Weems Law Office/ 106 Wesley Dr. SE

Request for Certificate of Occupancy
Transportation Development Final Inspection
Architect's Stamp dated 03-24-2020 (K16-D090)

## TRAFFIC CERTIFICATION

## WEEMS LAW OFFICE 106 WELLESLEY DR SE

SITE PLAN / ROOF PLAN

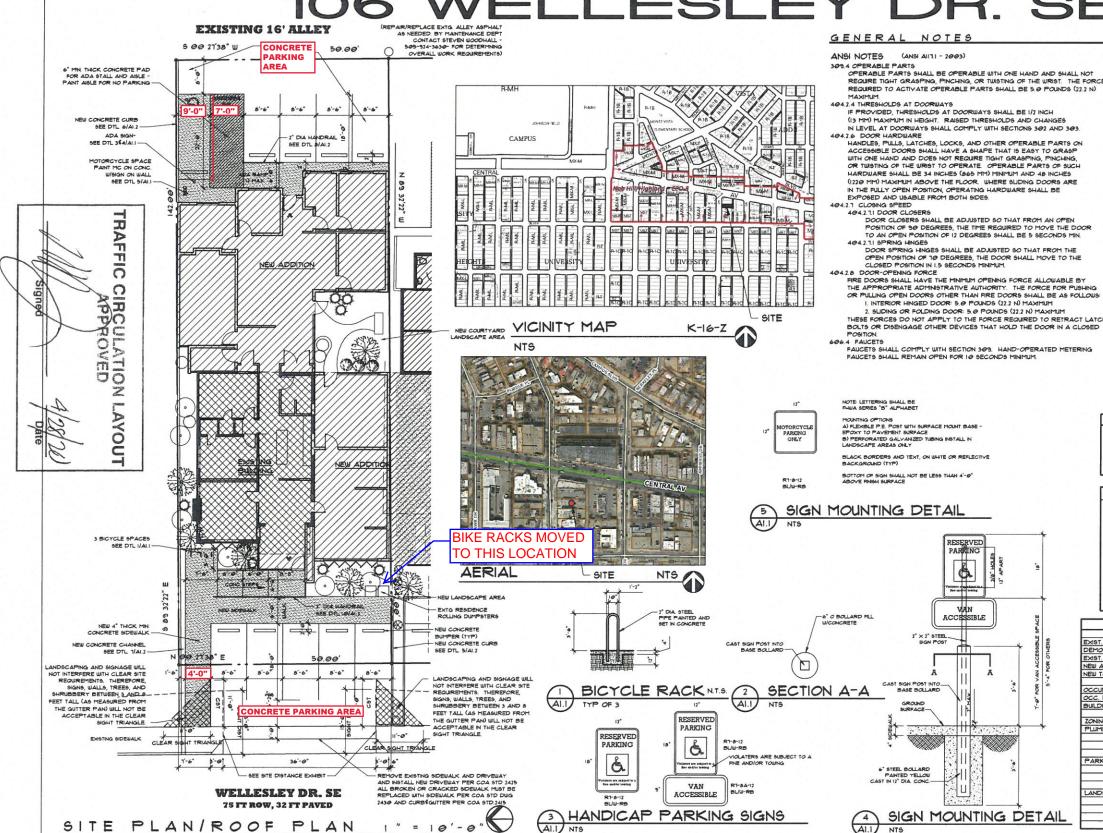
BIKE RACK HAS BEEN MOVED TO THE SOUTHEAST CORNER OF THE FRONT PARKING LOT

FRONT AND REAR PARKING AREAS ARE MADE OF CONCRETE THE WEST ADA PARKING SPACE WAS WIDENED TO 9'-0" WITH A DROPOFF AISLE OF 7'-0" WIDE.
